Authorized Field Change

AFC G-07912R

Subject: Inspect Drive Gear and/or Replace Power Steering Pump On MaxxForce 7 Engines

Model: 4300, CE Bus, BE Bus

Figure 1 Illustration of Part Number Location

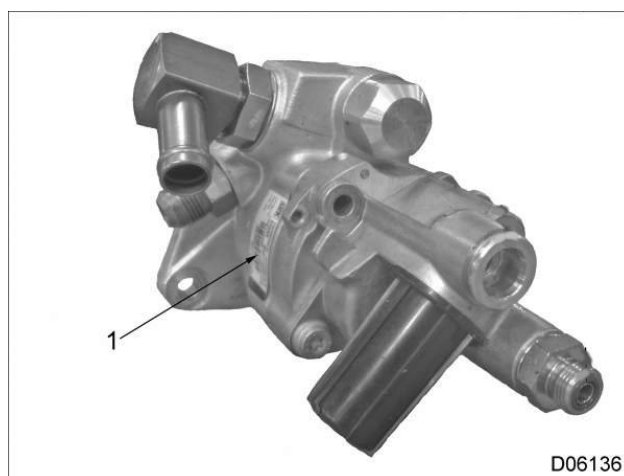
Based upon the Inspection results, if only the power steering pump requires replacement, use the parts table below to determine the pump needed.

1. Inspect Power Steering Pump Label: if no lot code label is found on the pump or it has an '06 build year, replace the pump (see Figure 2).
2. If Label has a lot code with 07 build year, no repair is needed (see Figure 2).
